STAFF REPORT SUMMARY

To: Edgerton Planning Commission
Fr: Kenneth Cook, AICP, CFM, Community Development Director
Re: PP2016-04, Preliminary Plat for Logistics Park Kansas City Phase VI, located on the South side of 183rd Street and East of Montrose Street.

To: Edgerton Planning Commission
Fr: Kenneth Cook, AICP, CFM, Community Development Director
Re: PP2017-02 Preliminary Plat for Logistics Park Kansas City Phase VI.

Preliminary Plat for Logistics Park Kansas City Phase VI

Sheet
C1

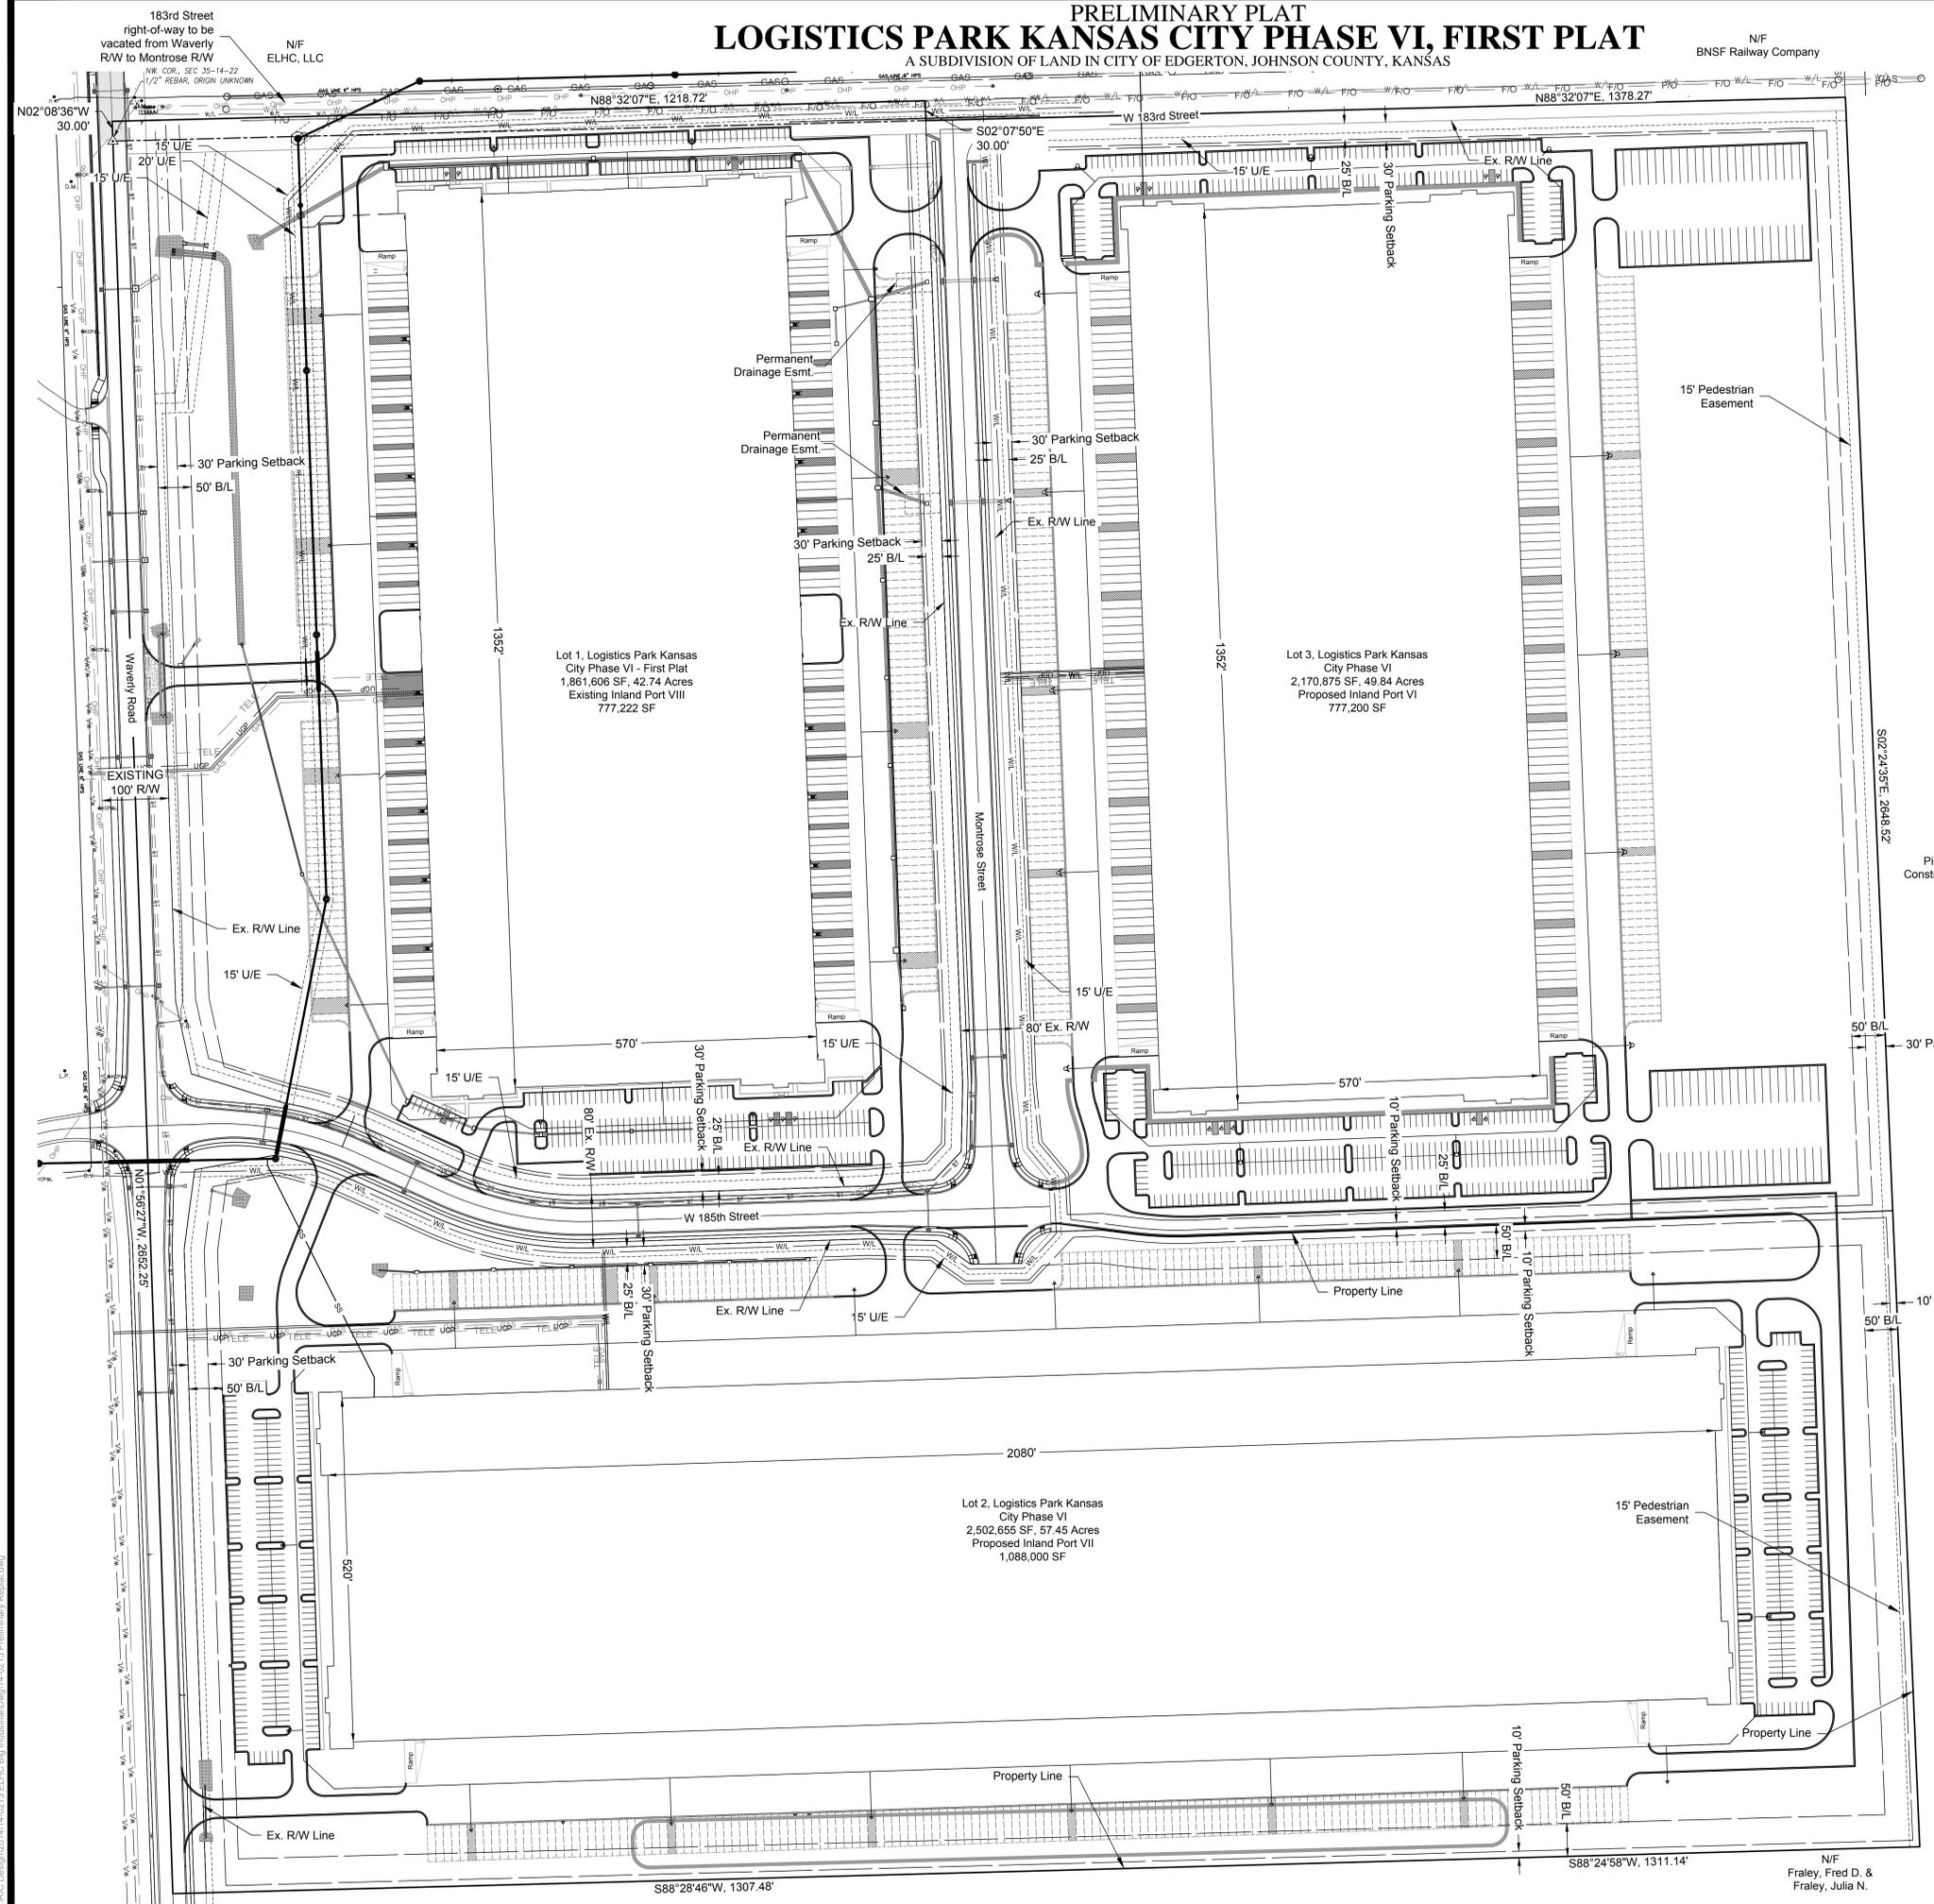
4. Name and seal of surveyor/engineer. **Preliminary Plat complies.**
5. Date surveyed. **Preliminary Plat complies.**
6. Adequate legend; vicinity map. **The vicinity (location) map should accurately depict "183rd, 185th, and Montrose Streets. It should depict, or call out that portion of Section 26-14S-T22E included as part of the preliminary plat and indicate the Edgerton City limits.**

dashed lines. **As currently drawn, it is difficult to discern the exterior (perimeter) lot lines of the preliminary plat, particularly along Waverly road and 183rd Street. That portion of 183rd Street right-of-way being vacated as part of this application must be better identified and the made more clear. The callout text and leader need revising. Please revise accordingly.**

12. Rights-of-way and/or easements proposed to be created for all drainage purposes, utilities, walkways, access, and other purposes. **Please increase the proposed 15 foot pedestrian/trail easement along the eastern property lines of lot 2 and 3 to 20 feet to accommodate the Active Transportation Network identified in the 2013 Southwest Johnson County Area Plan.**

13. Proposed location of streets, sidewalks, sanitary sewers, storm water sewers, water mains, and fire hydrants. Plat must show that the water distribution system and the sanitary sewer collection system touch upon each lot, or in an easement appurtenant to each lot. **The southwest drive access for Lot 3 raises and the central access drive for lot 2 should be further evaluated by the city engineer and applicant. The south curb line at the intersection of W 185th and Montrose Streets will need to be evaluated as well.**

16. Setbacks, yards and any entrance restrictions. Setbacks shall be shown as a building envelope representing that portion of the lot within the yards and setbacks that can reasonably contain, depending upon watercourses, topography or geology, the principal structure and the lateral field (if a lateral field is used). *With a building height of 48'-2" and the development abutting single-family residential uses and zoning on its eastern side, city regulations specifies 100 foot setback/building lines. Please show 100 foot setback/building line along the east side of lot 3 and 2.*

1. Rights-of-way must conform to the current standards of the American Public Works Association, and greater widths may be required by the Zoning Administrator after preliminary review; utility easements must be a minimum of fifteen (15) feet wide or, 7.5 feet for appurtenant utility easements on interior lots. Street lighting and fire hydrants must be indicated in areas planned for residential use. Cul-de-sacs are limited to 800 feet in length. **Please depict right-of-way for 183rd Street more clearly.**

5. Side lot lines shall be substantially at right angles to street lines. **The lot lines are difficult to discern. The internal lot lines should be dimensioned and clearly identified. Revise Preliminary Plat.**

6. Drainage and watercourse easements are required. Building setbacks from watercourses should be measured from the thread of the stream. Flowage easements may be used to calculate required minimum lot sizes. ***Drainage/storm sewer and detention area easements have not been specifically noted. If wetlands or similar areas are present additional easements may be required.***

- Please revise preliminary plat name by removing text "first plat" and adding text for Section-Township-Range.
- Edgerton regulations requires 100 foot side/rear setbacks when L-P zoning and uses are adjacent to single-family residential homes. The entire eastern side of the development is adjacent to single-family residential homes. While the single-family residential homes are located within the city of Gardner, staff recommends the preliminary plat provide 100 foot setbacks along its eastern side.
